ADDENDUM NO. 1
TO
PLANS AND SPECIFICATIONS
FOR
KAIWIKI HOMESTEAD ROAD BRIDGE REHABILITATION
BRIDGE NO. 26-7
COUNTY JOB NO. E-3917
SOUTH HILO, HAWAI'I
COUNTY AND STATE OF HAWAI'I

ADDENDUM NO. 2
TO
PLANS AND SPECIFICATIONS
FOR
KAIWIKI HOMESTEAD ROAD BRIDGE REHABILITATION
BRIDGE NO. 26-7
COUNTY JOB NO. E-3917
SOUTH HILO, HAWAII
COUNTY AND STATE OF HAWAII

ADDENDUM NO. 3
TO
PLANS AND SPECIFICATIONS
FOR
KAIWIKI HOMESTEAD ROAD BRIDGE REHABILITATION
BRIDGE NO. 26-7
COUNTY JOB NO. E-3917
SOUTH HILO, HAWAI'I
COUNTY AND STATE OF HAWAI'I

Sheet
7
of 7

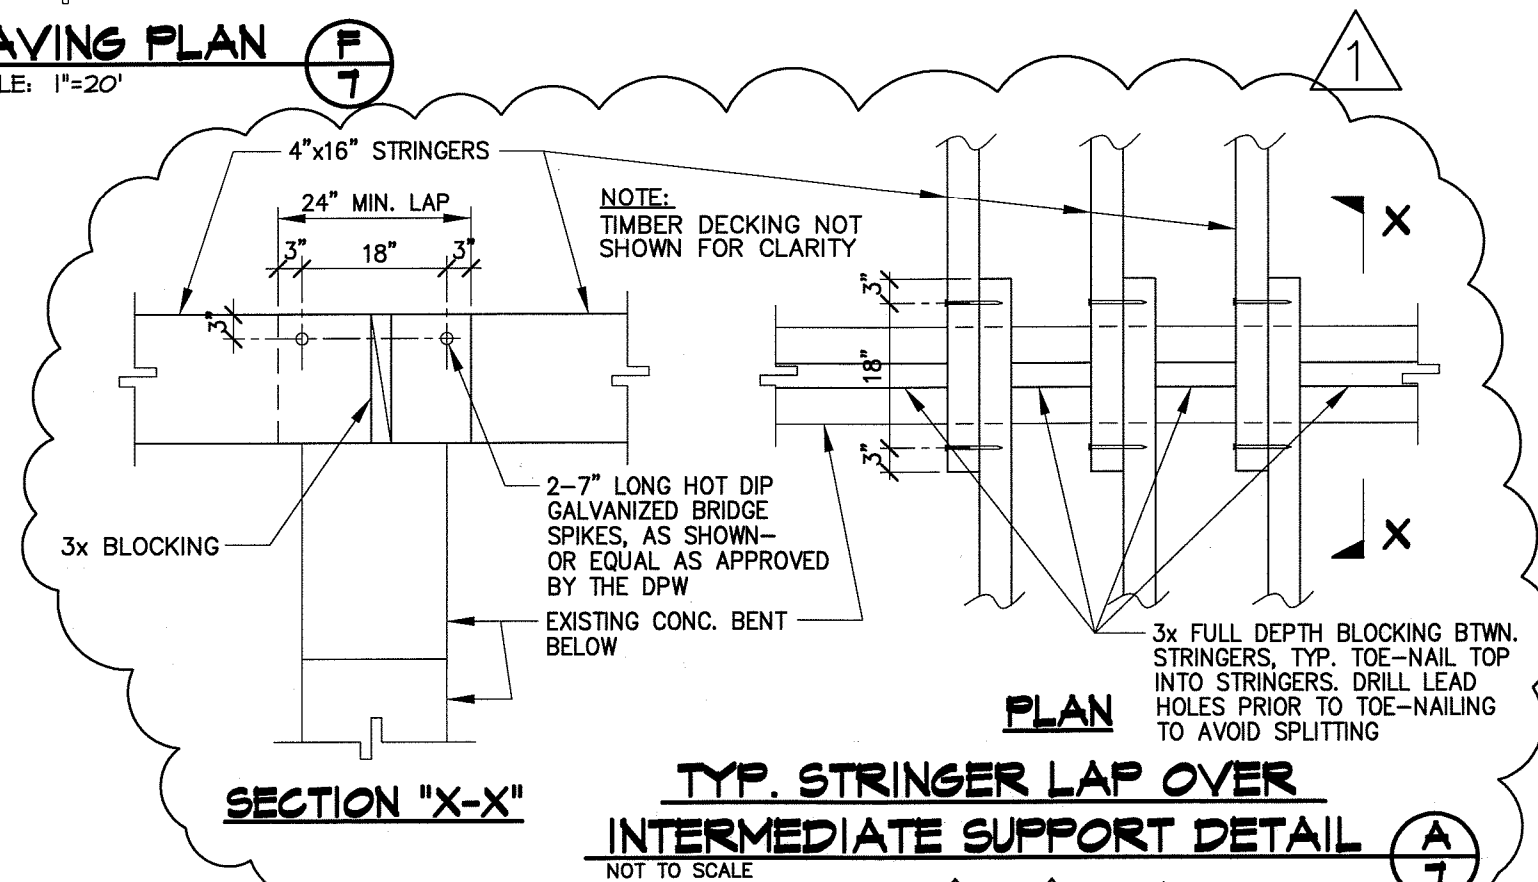
Sheet 7 of 7: **DELETE** the existing Sheet 7 in its entirety and **REPLACE** with the attached revised Sheet 7.

Reference Drawing Detail A/7

Q. Clarify method of fastening the stringer lap over intermediate support

A. Clarified via Addendum No. 1 (Replacement Sheet 7 of 7 Revised Detail A/7 issued)
